# Product Update 10091

## MS Sedco Introduces 2-Switch Bollards, Double-Switch ClearPath™ Wireless Kits

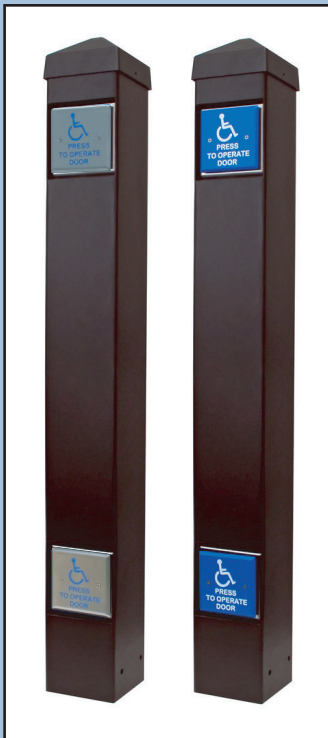
In response to this code requirement, and to better serve the needs of the disabled everywhere, MS Sedco is please to introduce standard part numbers for bollards including two switches as well as ClearPath kits containing switches and transmitters to cover the lower locations.

The dual-switch bollards feature all of the same benefits of the 608 bollard: rugged 1/8” thick tubular steel construction, LongLife™ finish, and a rust shield. The dual-switch ClearPath™ kits feature familiar ClearPath™ features including field-selectable frequencies and extended transmission time.
